# PLANNING COMMISSION MEETING AGENDA REGULAR MEETING

May 24, 2022 7:00 P.M. Council Chambers

PRELIMINARY SITE PLAN APPROVAL (File Number SP2019-0041) – Proposed Lange View Estates, East of Crooks Road, Southeast corner of Livernois and Leetonia (4080 Livernois), Section 15, Currently Zoned NN Neighborhood Node (Node "H") District.

#### Site Plan Review For City of Troy, Michigan

**OVERALL SITE PLAN:**

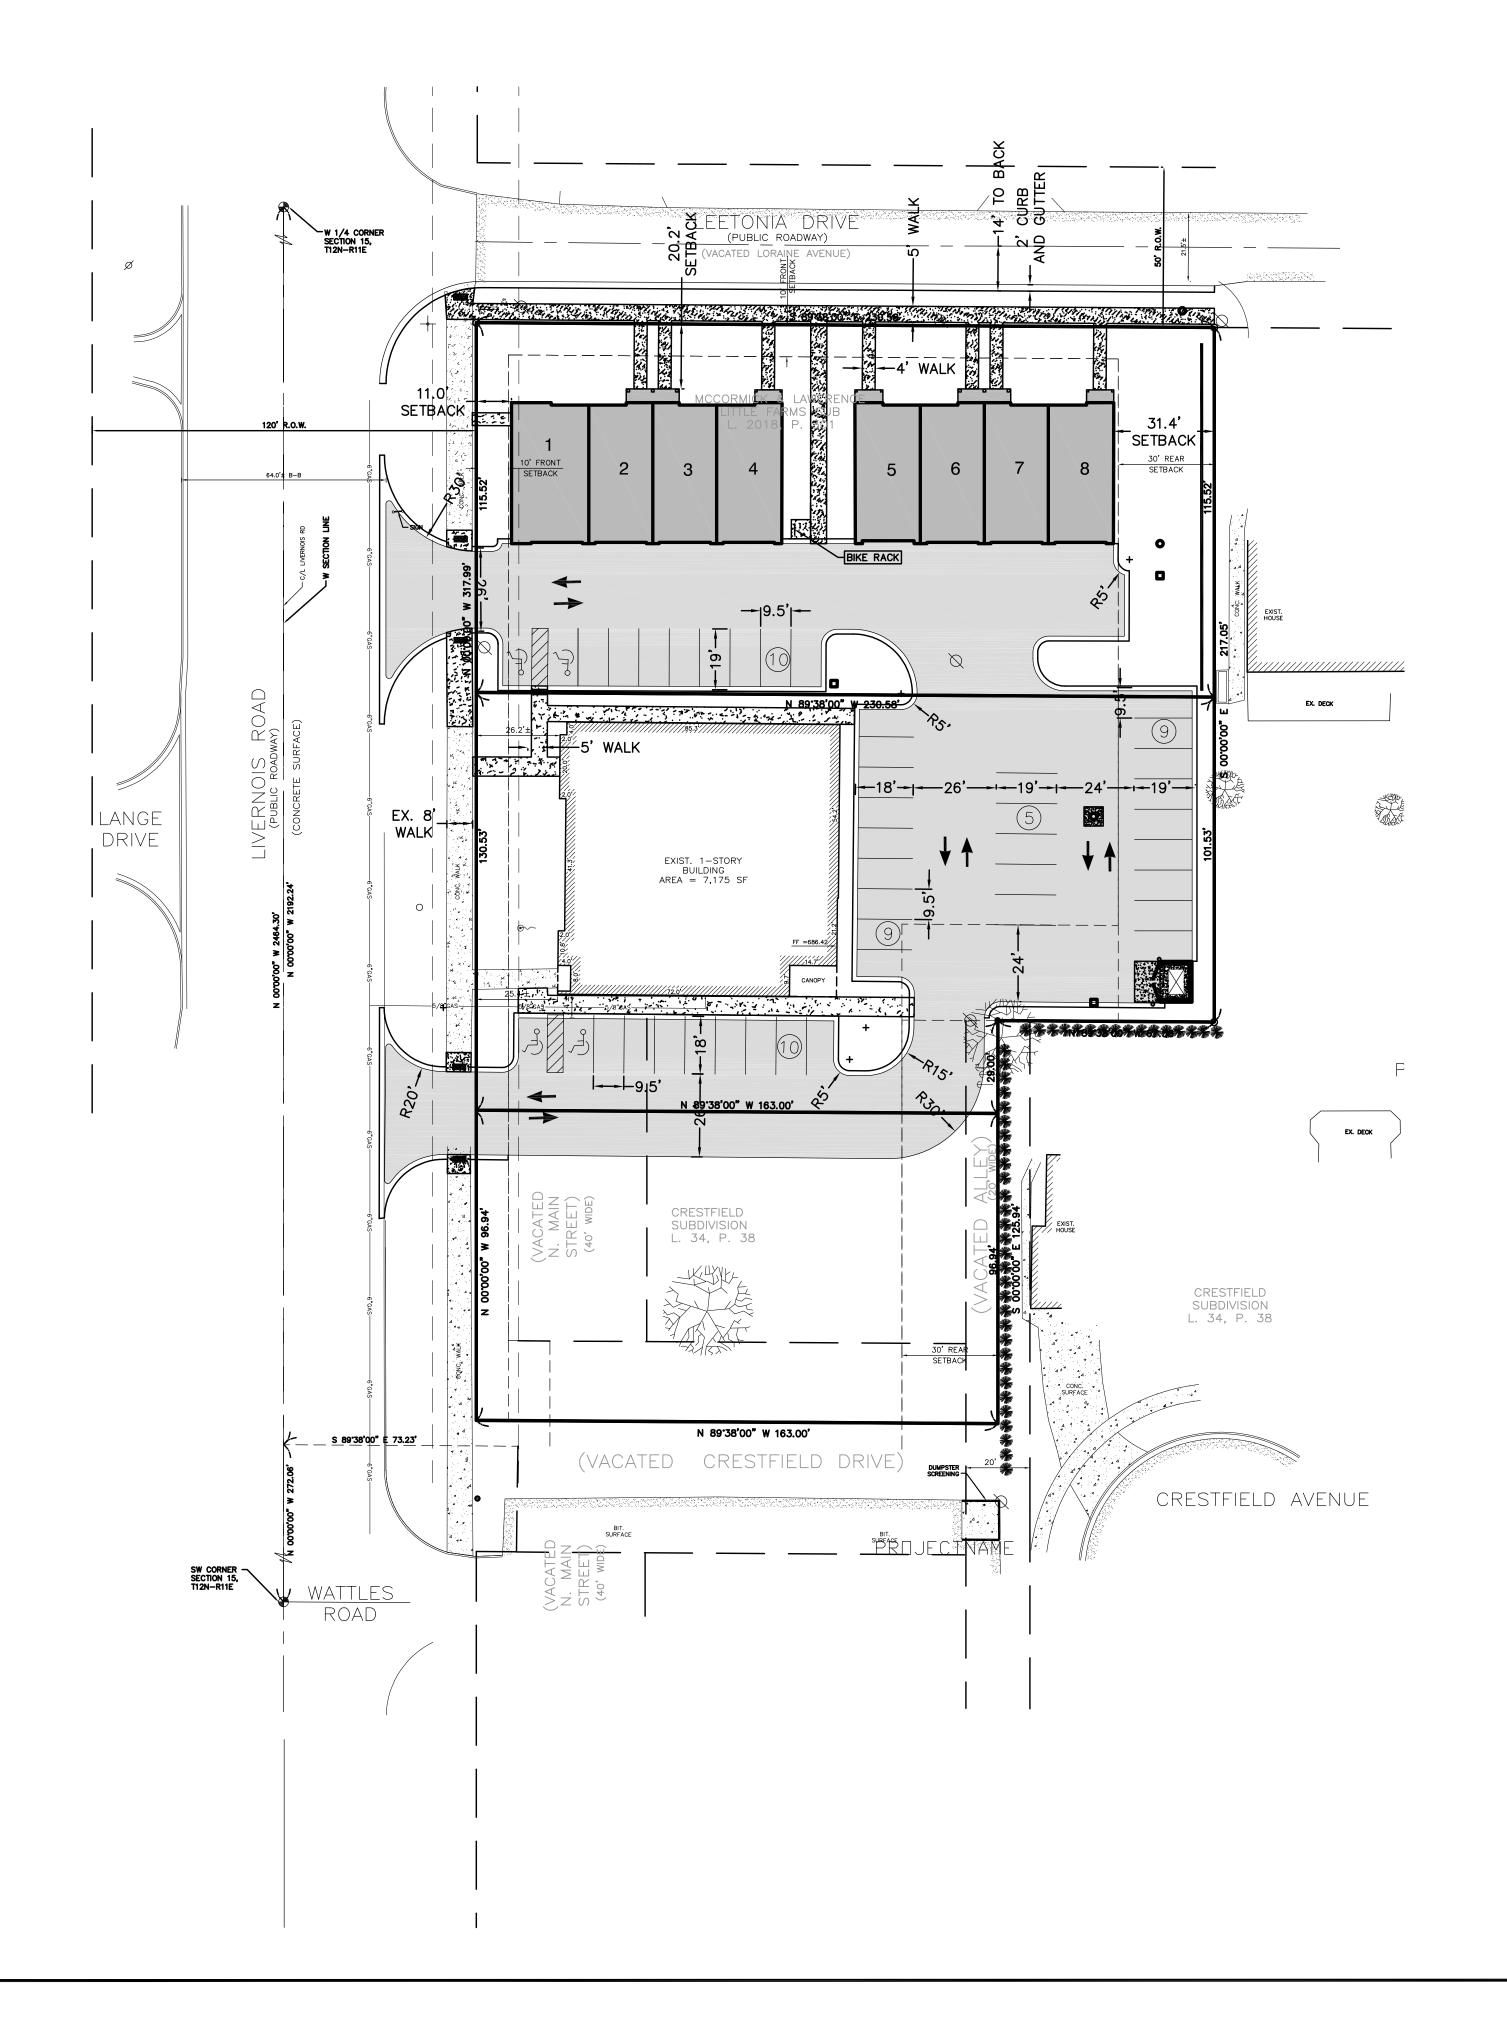
The site, particularly the office site is overparked. Parking that exceeds 20% of the required minimum requires Planning Commission approval. The required parking (40 spaces) plus a 20% excess is a total of 48 spaces. The applicant is seeking approval for 59 spaces. A shared parking agreement will need to be recorded.

**Items to be Addressed:** Either obtain parking waiver from Planning Commission, remove additional parking, or landbank parking

Vehicular access to the site is via the two driveways off Livernois Road. Site plan provides a 26' wide fire access drive-aisle. The applicant has provided the required turning fire engine template.

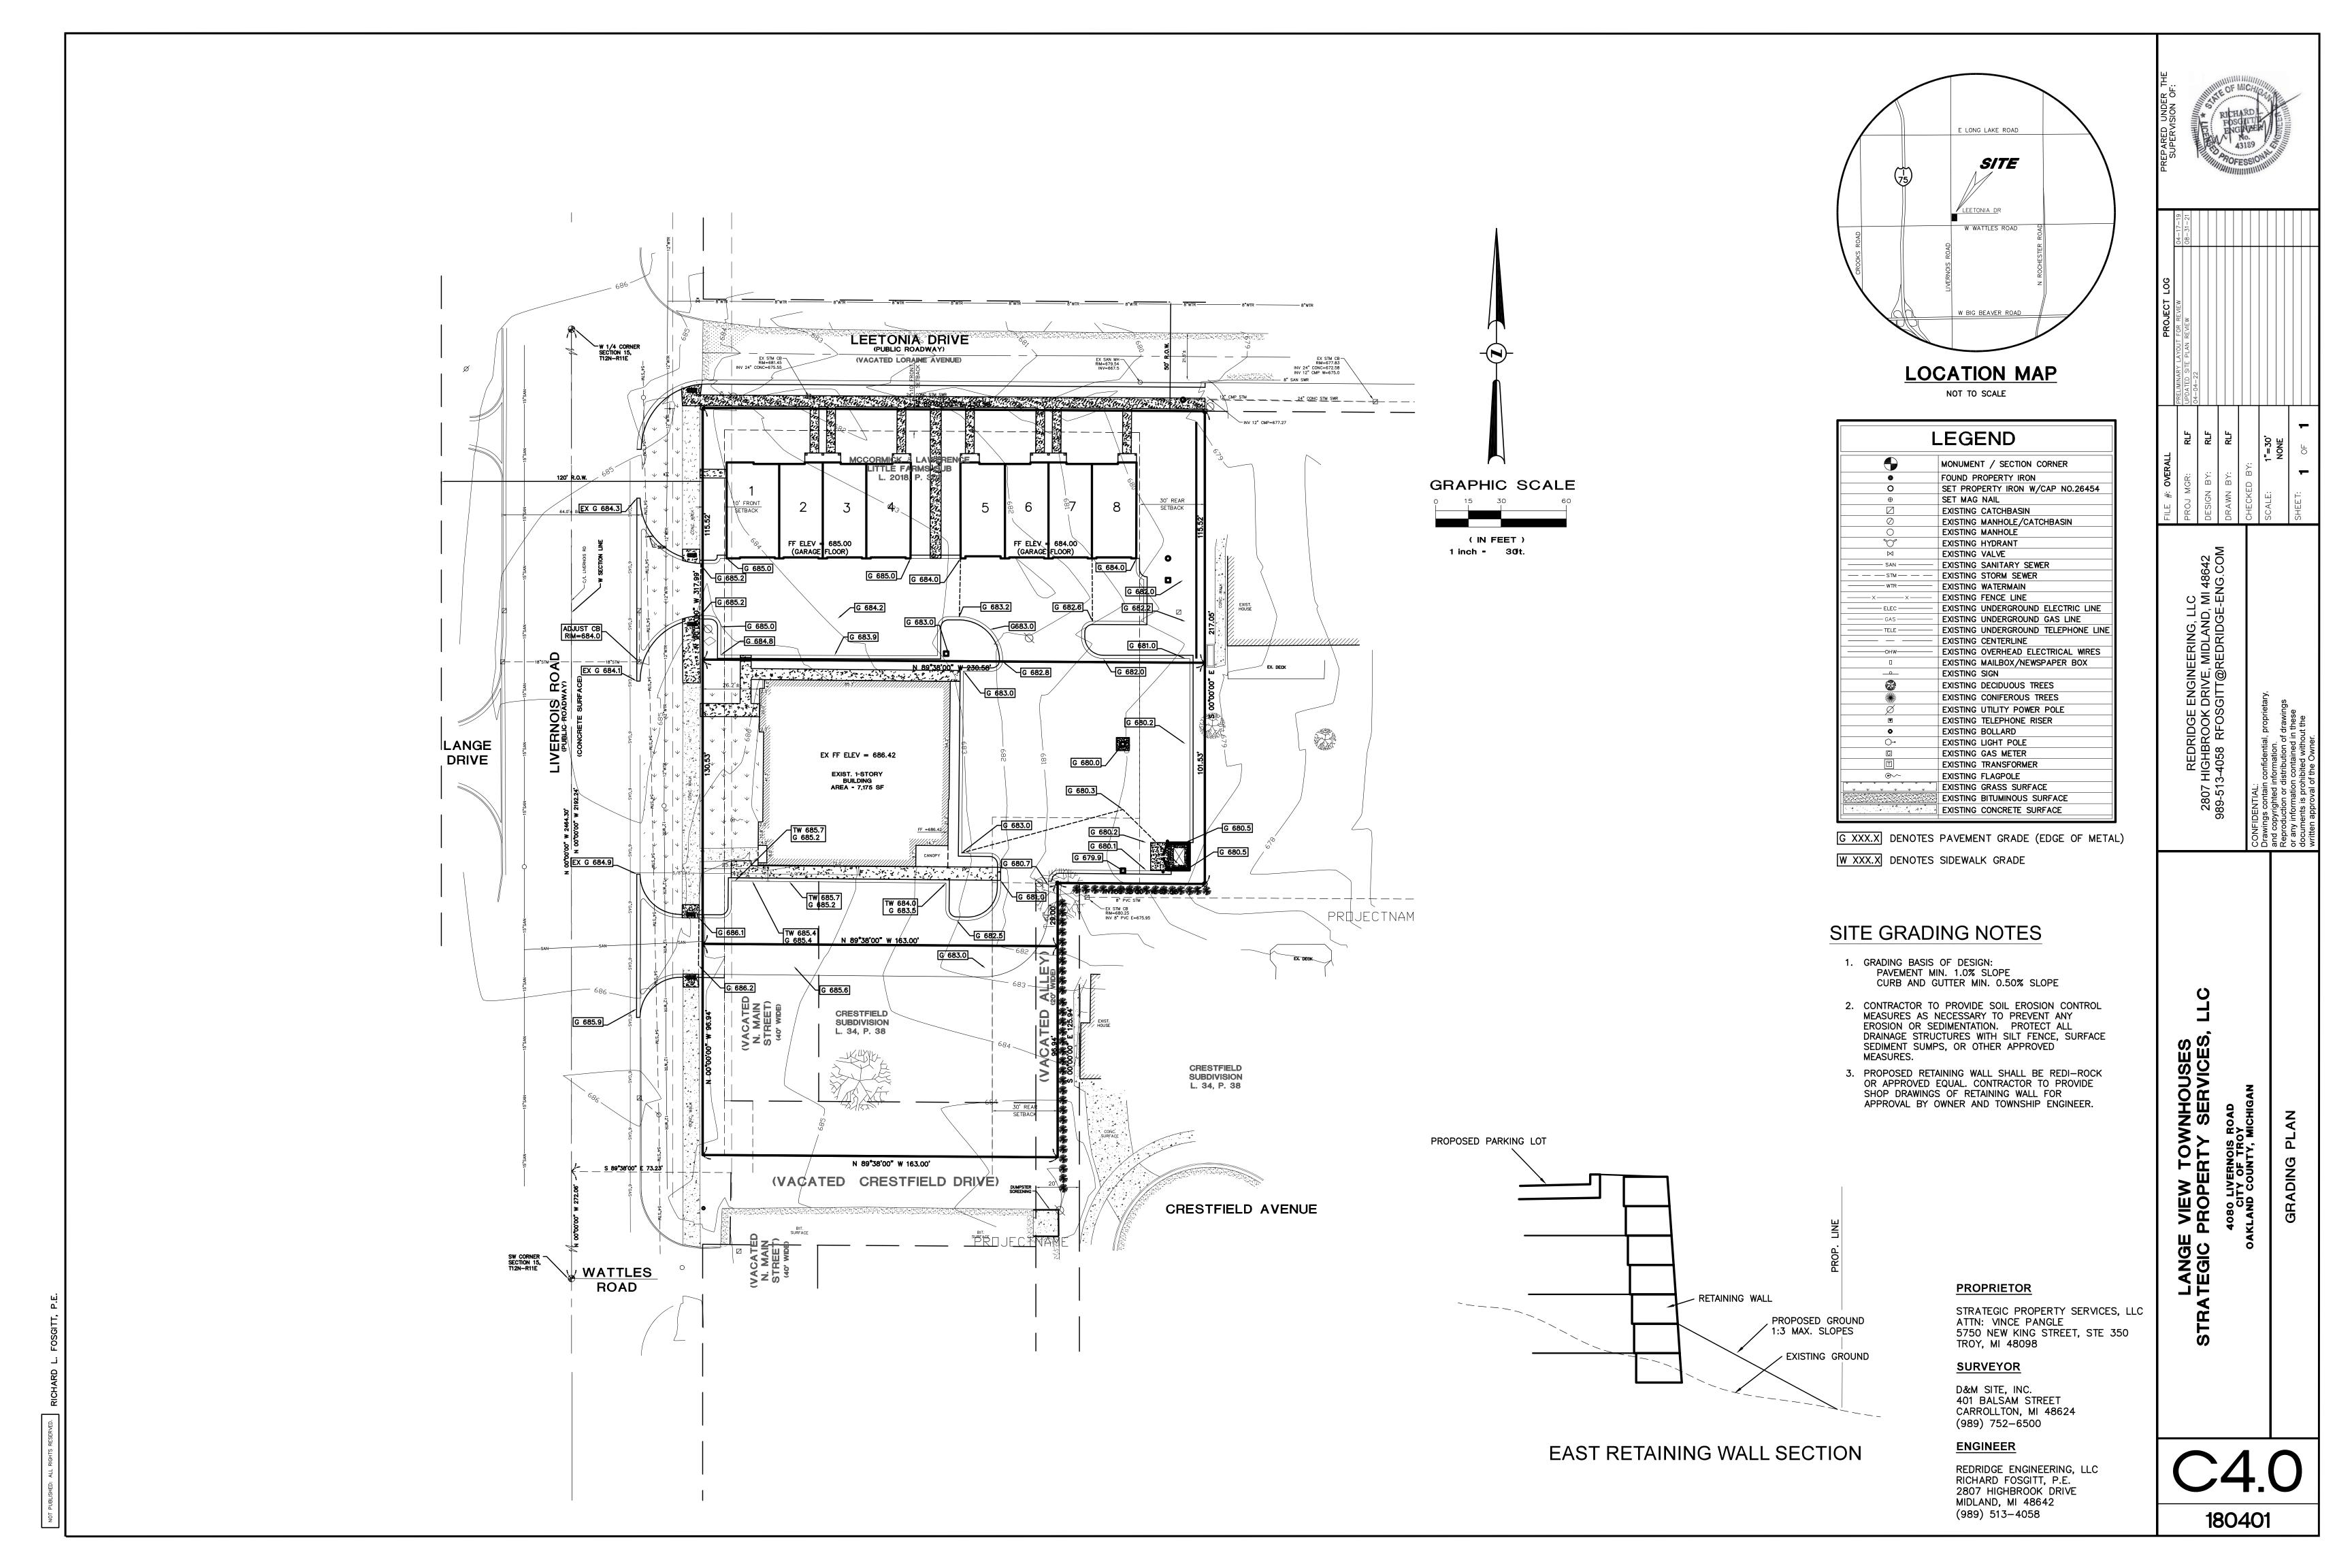
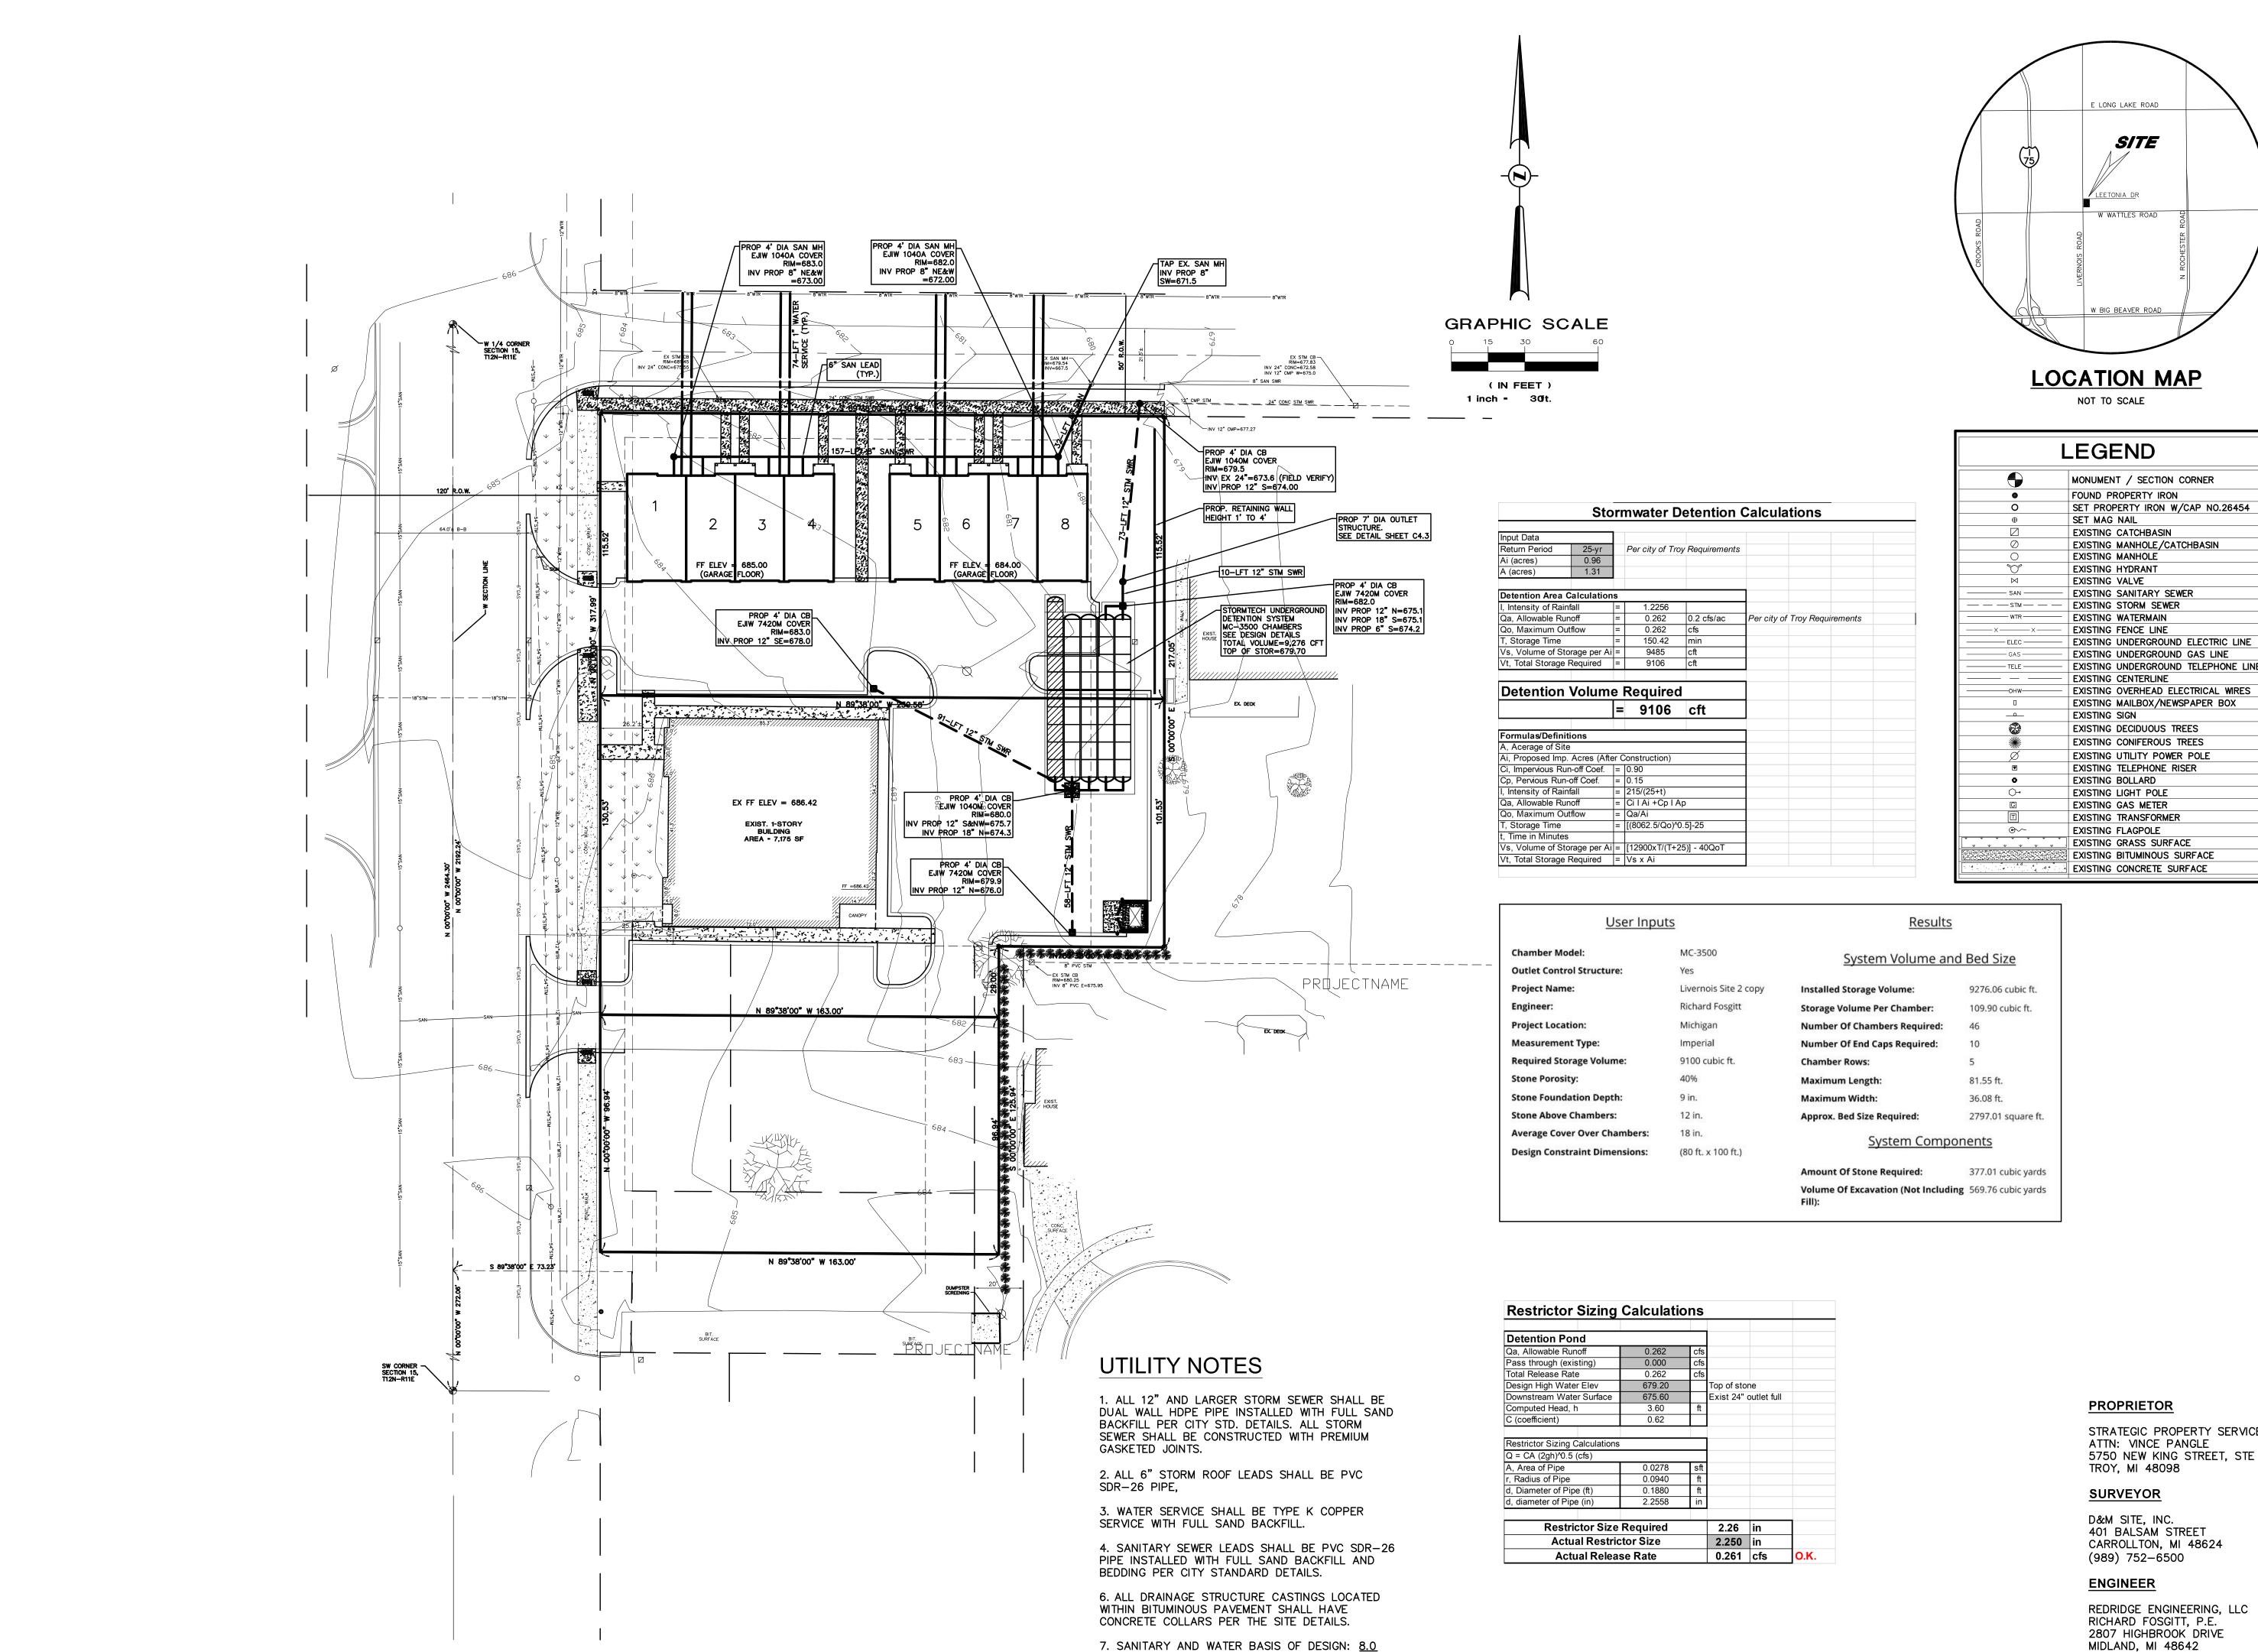
A landscaping plan has been provided on page C5.0. The following table discusses the development's compliance with the landscape requirements set forth in Section 13.02.

Add three additional parking lot trees. Applicant shows trash enclosure but does not indicate screening.

**Items to be Addressed**: 1). Provide trash enclosure details in accordance with section 13.03B; and 2). Provide three additional parking lot trees
